TOOLBOX XL

750cc

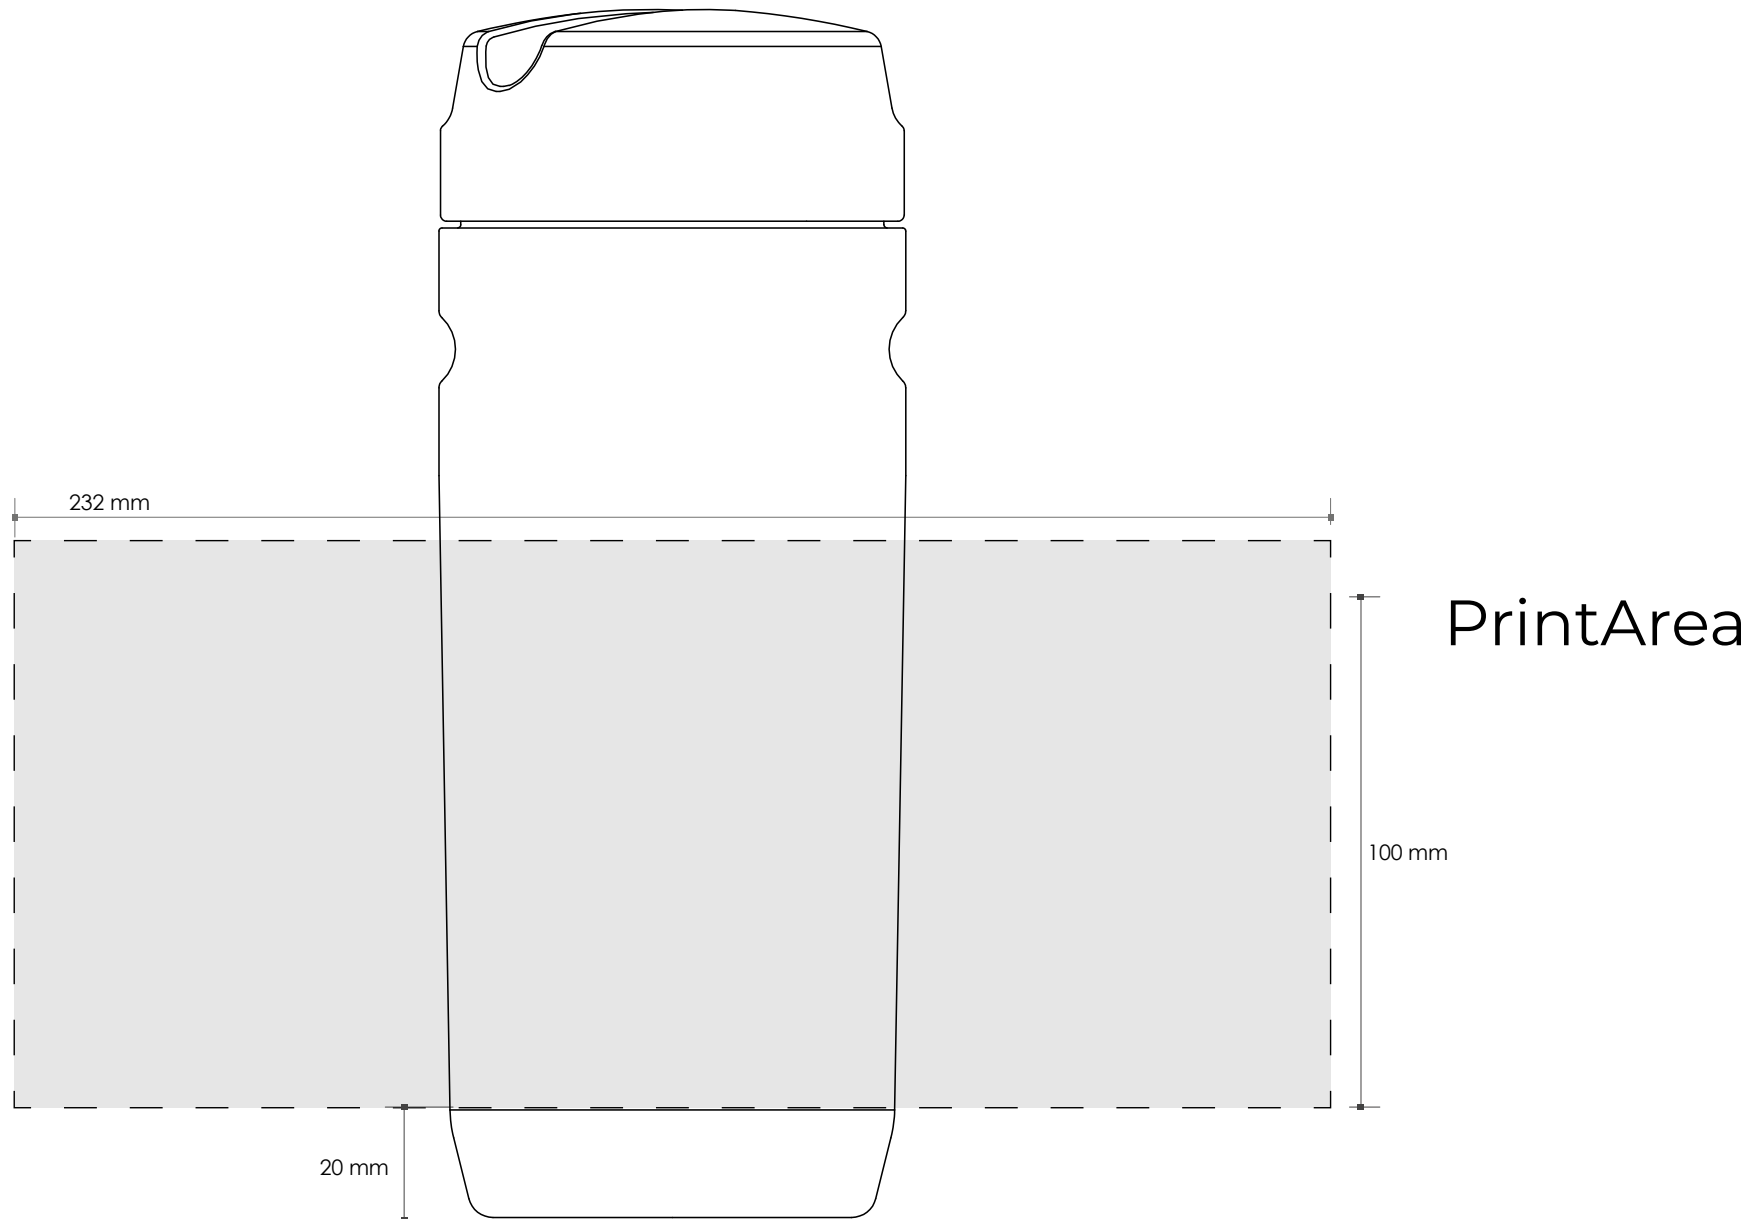
The impression can not close on the circumference of the bottle:
it's necessary to consider a non-printable area (approx. 0,8 cm width)
